APPLICATION NO.	FILING DATE	FIRST NAMED INVENTOR	ATTORNEY DOCKET NO.	CONFIRMATION NO.
10/789,218	02/27/2004	Dennis Redman	52067/MEG/B603	9117
23363 7590 10/05/2007 CHRISTIE, PARKER & HALE, LLP PO BOX 7068 PASADENA, CA 91109-7068			EXAMINER TYLER, STEPHANIE E	
			ART UNIT 3754	PAPER NUMBER
			MAIL DATE 10/05/2007	DELIVERY MODE PAPER

Office Action Summary

Detailed Action

APPENDIX A

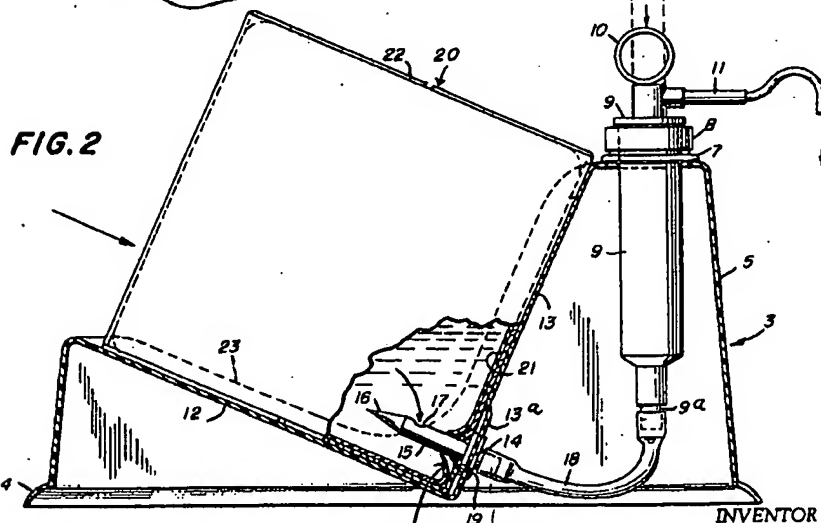
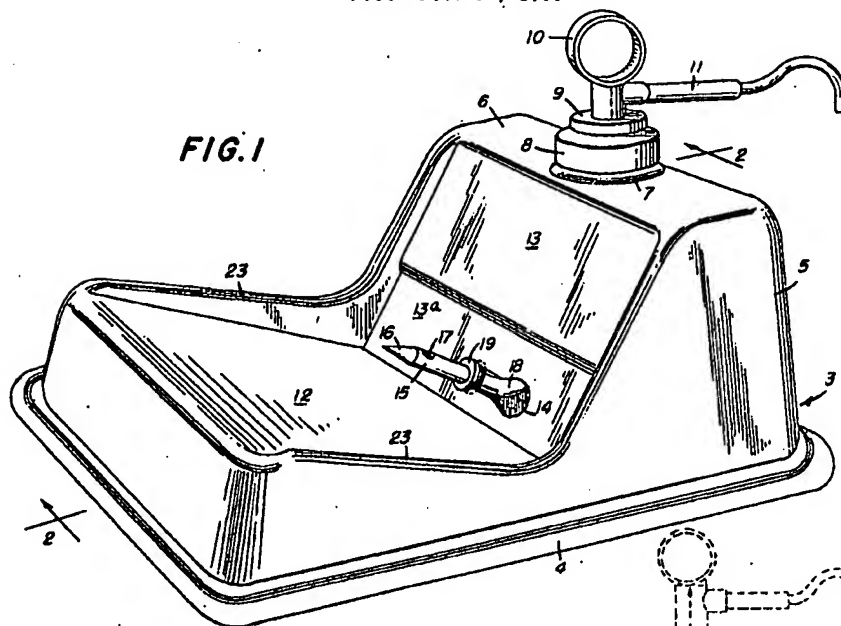
The Speas reference discloses a liquid feed system consisting of at least one liquid dispenser having a manually operable positive displacement pump (9); a collapsible fluid container (21) defining an outlet (fig.2)¹ having a nozzle (fig.2) extending from the outlet and configured to collapse as soap or lotion therein is pumped from the outlet (fig.2) by the manually operated positive displacement pump (9), the collapsible fluid container (21) located at an elevation lower than the elevation of the at least one liquid dispenser (when the liquid dispenser is in the dispensing position); and at least one line coupling (18), in fluid communication, the nozzle (fig.2) of the collapsible fluid container (21) to the at least one soap or lotion dispenser.

Re: claim 39 the outlet (fig.2) of the fluid container (21) is located at a bottom of the fluid container (21).

Re: claim 40 the outlet (fig.2) of the fluid container (21) is located at a lower side portion of the fluid container (21).

3. Applicant's arguments filed July 26, 2007 have been fully considered but they are not persuasive. The applicant argues that the Speas reference does not disclose or suggest a nozzle extending outward from the container. The Office has shown in Appendix A the nozzle extending from the outlet of the collapsible container.

Dictionary.com Unabridged (Based on the Random House Unabridged Dictionary) defines a nozzle as, "a projecting spout, terminal discharging pipe, or the like, as of a hose or bellows". Therefore the projecting end the probe (15) is considered a "nozzle".
